Subject: Vent Installation  
Leon Valley Veterinary Clinic  
6701 Bandera Road  
Leon Valley, Texas

Re: Completed Actions and Proposed Vents Document  
Leon Valley Veterinary Clinic  
6701 Bandera Road  
Leon Valley, Texas

**EPA Comments on the  
Completed Actions and Proposed Vents Document  
October 6, 2009**

File Name: Figure 6 - PID July 2009.SKF  
SEPT 2009

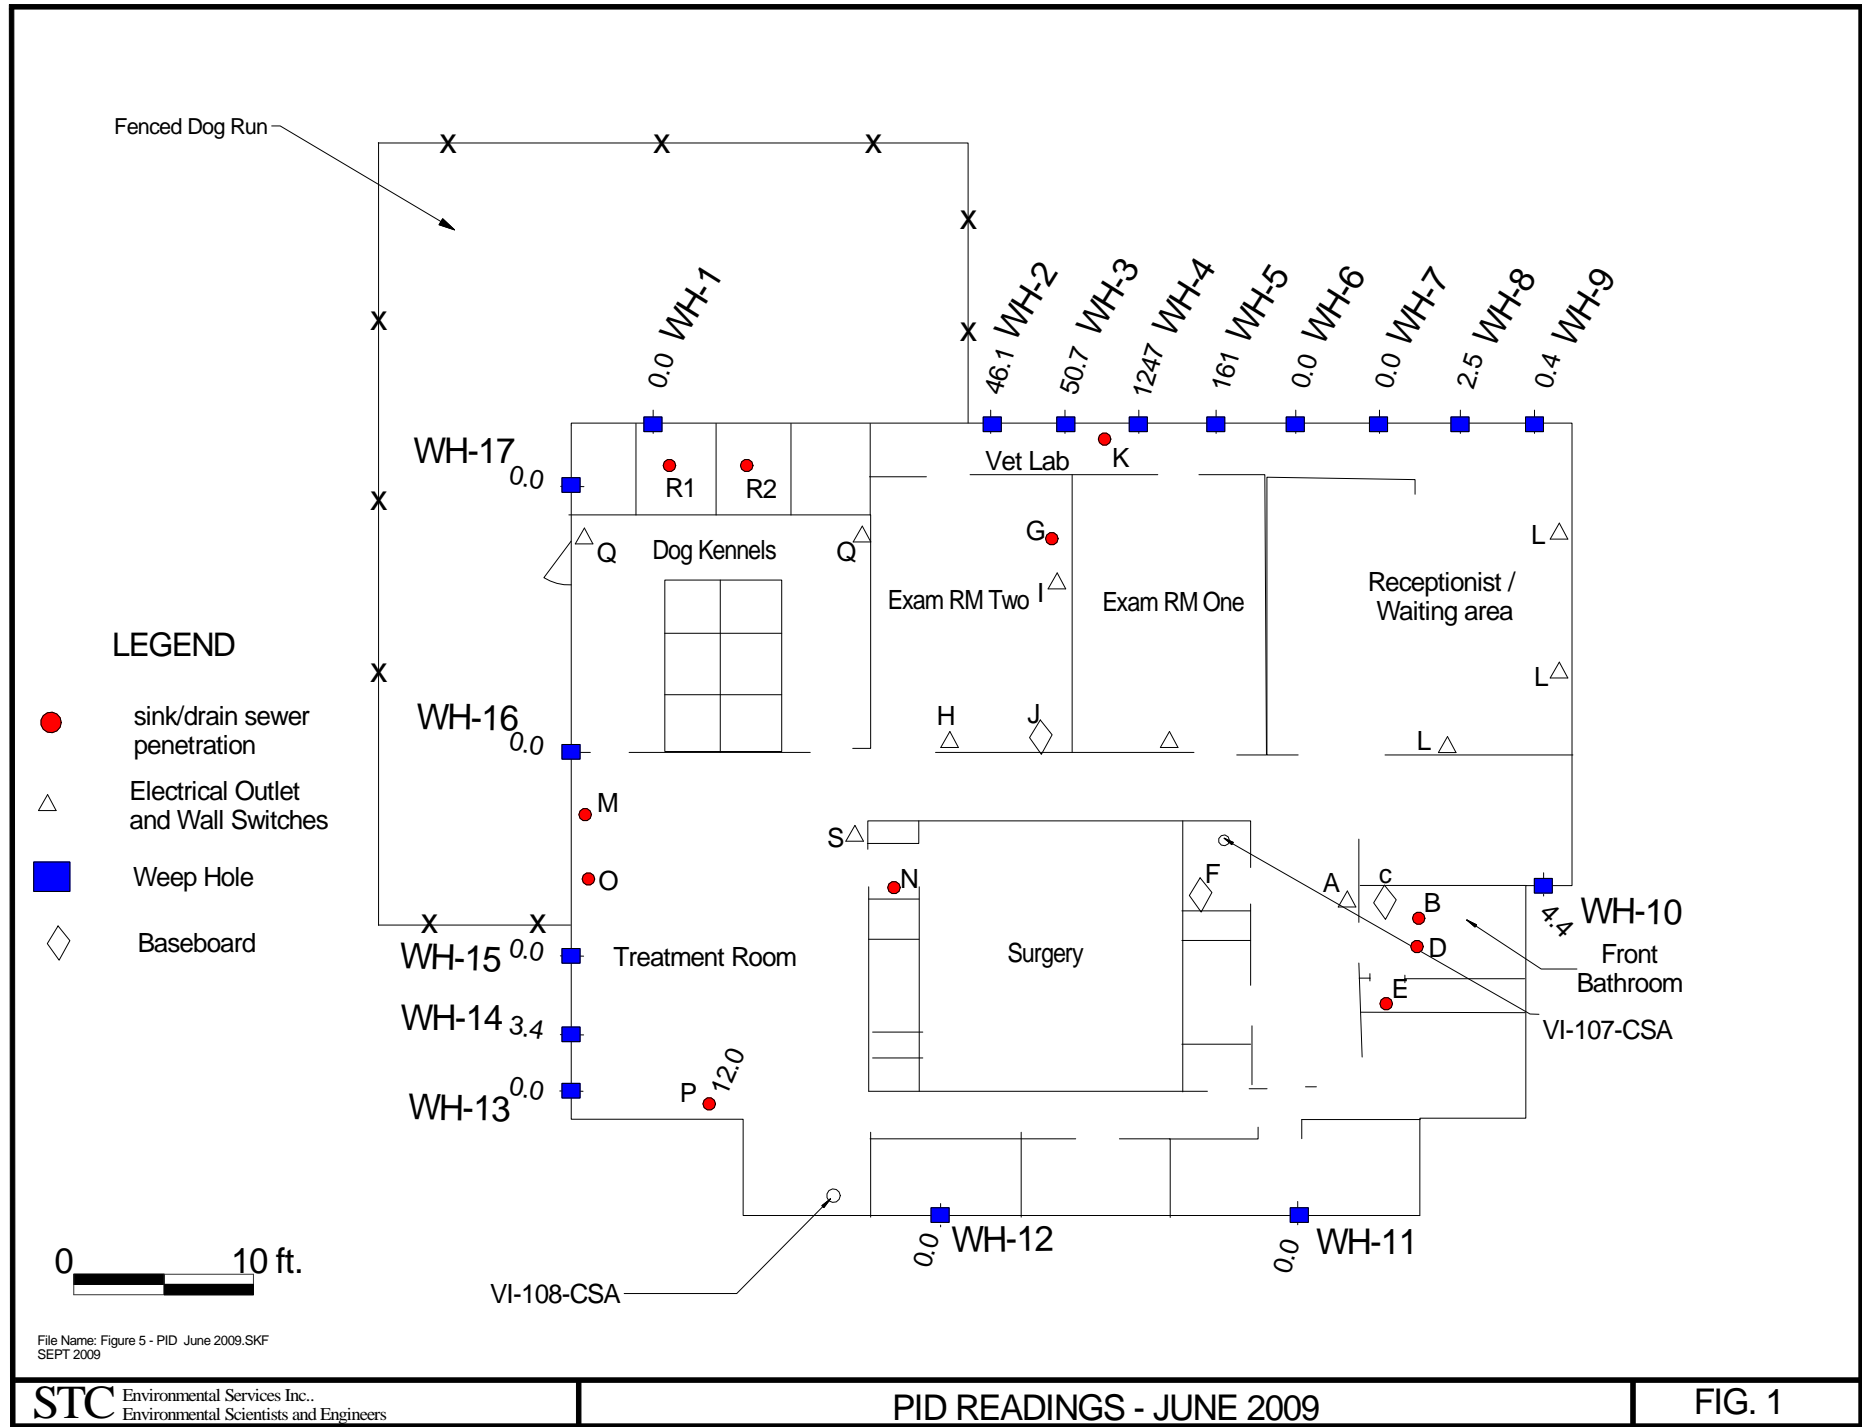
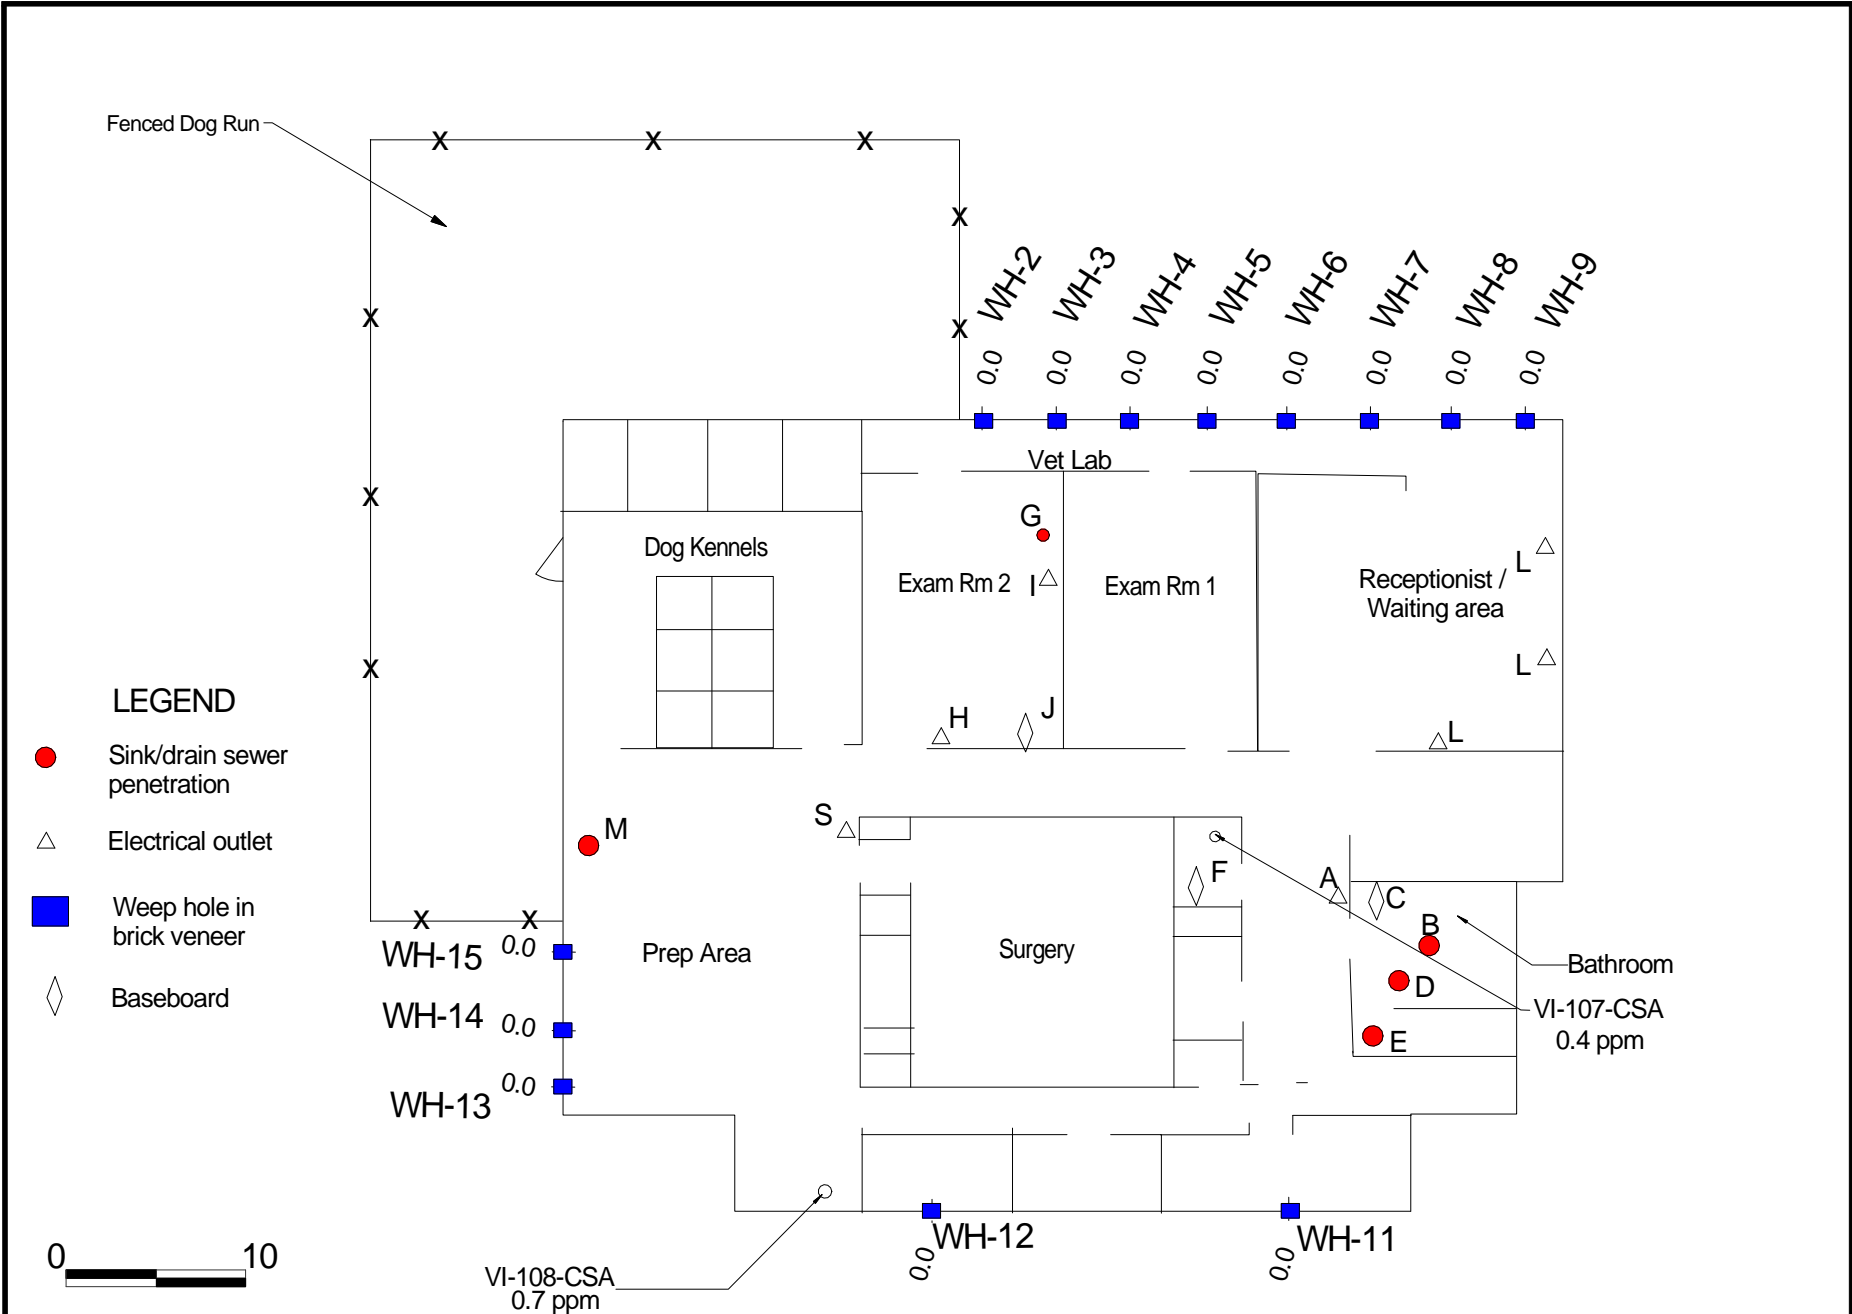
Figure 5 identifies seventeen weep holes. Readings for sixteen weep holes were reported in Table II. Figure should include weep hole numbers and/or text which indicates the weep hole numbering system used for the corresponding tables.

Section 1 of the EPA Comment letter also requests weep hole numbers also be presented on the corresponding figures. These revisions are shown on Figures 1 and 2.

**FIG. 3**

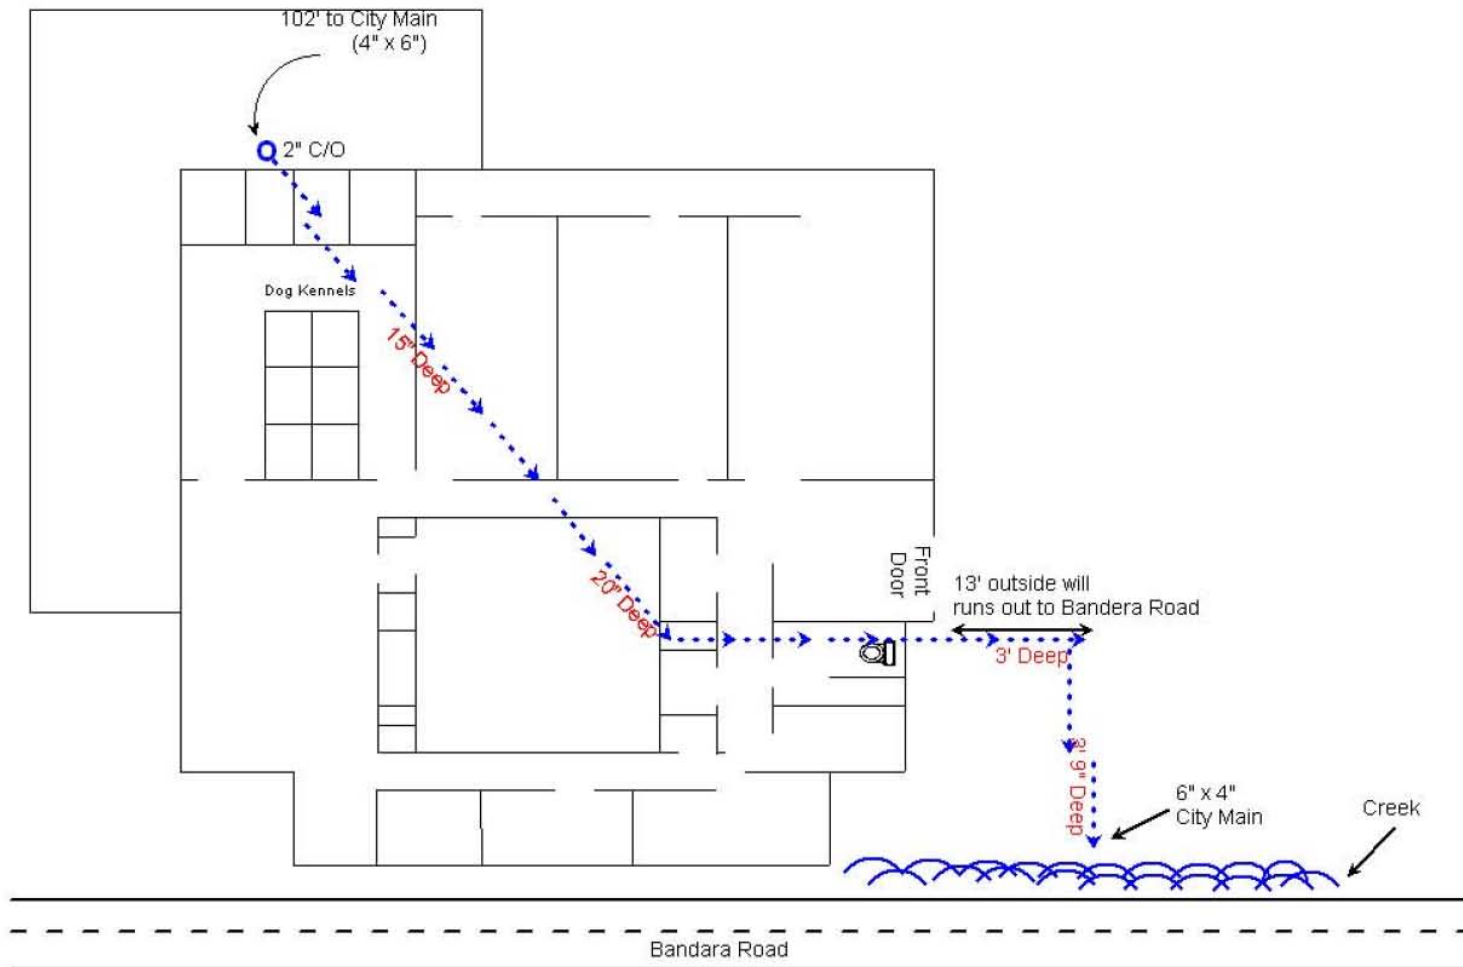
The work by E.L. Smith also located the larger lines under the slab of the Vet Clinic. This work revealed the larger main line under the slab extends to the northwest portion of the building where a cleanout is located on the exterior wall on the kennel area. These main lines are shown on Figure 3. Smaller lines for several sinks and other plumbing fixtures were not identified. However, estimated locations of these secondary lines are shown on Figure 4.

Figure 7 shows the estimated location of the sewer lines on part of the building and notes that a camera inspection of the sewer line is proposed to locate a portion of the existing system. In addition to camera inspections, plumbers have other tools to identify the location of sewer lines. Knowing the location of the sewer lines for the building would provide valuable insight as to the potential for the vent system to reduce organic vapor concentrations for the entire building sub-slab and not just the area under the north end of the building.

E.L. Smith Plumbing of San Antonio performed a camera inspection of the sewer lines at the Vet Clinic on November 20, 2009. This camera inspection revealed a sanitary sewer line exits the building at a point near the front entrance to the building on the southeast side of the structure.
